Answers to Comments

This document indicates the comments from RC1 and RC2, our response and where these comments are incorporated in the new version of the document.

Response to RC1 comments

Figure 1: Wave elevation evolution.

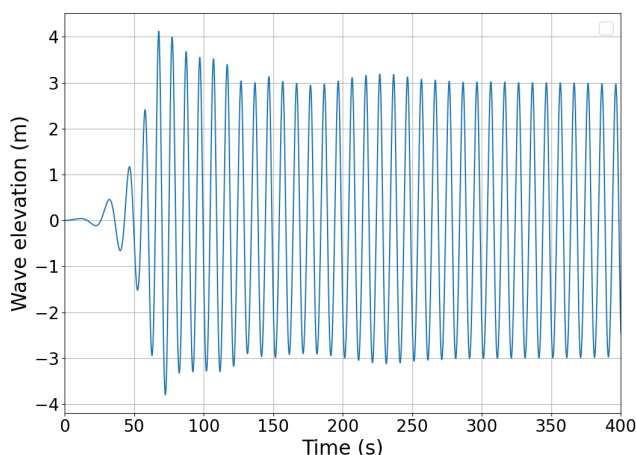
4. Please specify the wave theory which is used to generate the wave. And the figure 6 should present the more results to make sure the wave is simulate accurately. Form the presented results, it is hard to estimate whether the wave amplitude decreases with time or not

The wave model employed to generate the wave is STOKES II according to the relationship between wave height, wave period and water depth. Figure 6 was included to demonstrate why there is not a oscillatory response of the FOWT at the start of the simulation. As you suggest, the complete wave elevation time series will be updated. Below you can see the complete wave elevation series.
